**Antarctic Research Vessel Science Advisory Sub-Committee (ARV SASC)  
of the Office of Polar Programs (OPP) Advisory Committee**

**Report on DR #4, March 13, 2023**

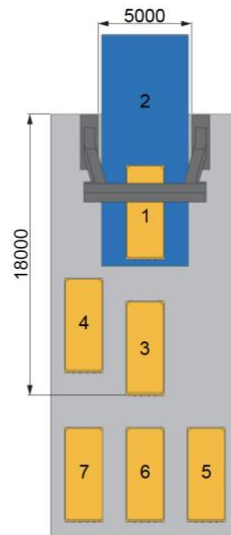
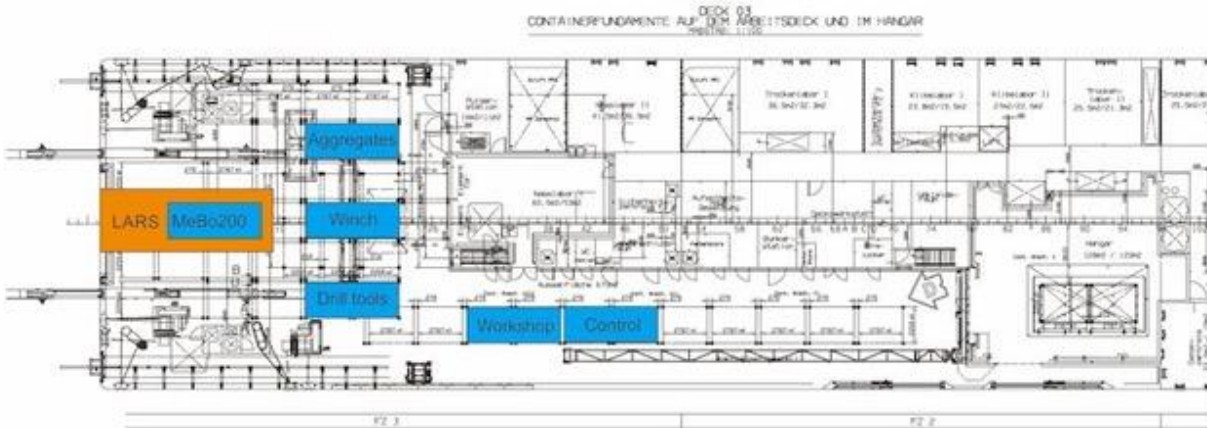
Note that MeBo Seabed Drilling requires a A-Frame lifting capacity (min) of 30 t; this is one drilling system that is being considered for use on the ARV

([https://www.bauer.de/export/shared/documents/pdf/bma/datenblatter/MeBo\\_EN\\_905.808.2.pdf](https://www.bauer.de/export/shared/documents/pdf/bma/datenblatter/MeBo_EN_905.808.2.pdf)). We ask for clarification on the conversion of the lifting capacity of 30 t indicated in the MeBo literature, from t to lbs. What does the lifting capacity need to be? Is the 40,000 lbs capacity (Science Systems Report, Table 3) adequate?

From the director of MeBo Operations and Engineering (Tim Freudenthal):

- Space: 18 x 4.7 m in line of the A-frame for launch and recovery system including winch. In addition, the possibility to install four 20' containers in the vicinity of the launch and recovery system is required.
- Laboratory for serving logging tools
- Storage room for liner and spare parts
- A-frame and loads: The umbilical (OD 35.5mm, breaking strength 910 kN), winch and overboard sheave belong to the MeBo system. Maximum line safe working load of about 300 kN (= 67,000 pounds). Total wire length of 2700 m currently (could be longer if more space for their portable winch).
- Deck loads in the area of launch and recovery system (weight: 20 metric tonnes plus 13 metric tonnes for the drill rig) and winch (30.5 metric tonnes = 34 US tons). Details of deck loads

depend on the mounting positions and have to be checked separately. Engineering advice needed.

- The total weight of the MeBo system shipped within 7 containers is about 115 metric tonnes. (about 126 US tons)
- Power: 400V and 50Hz, total amperage required is about 500A.
- Staff - 9-10 operator/technicians per cruise.
- Deck Layout:

- 1 MeBo
- 2 LARS
- 3 Umbilical Winch
- 4 Tool Container
- 5 Control Container
- 6 Power Pack for winch and transformer unit
- 7 Workshop Container

The umbilical winch, the MeBo, LARS and A-Frame have to be in line. The containers 4 – 7 can be stored anywhere on deck of the ship. Required space for installation of LARS and umbilical winch: 18 m x 5 m in line with A-Frame  
Additional space: 4 x 20' containers + working area
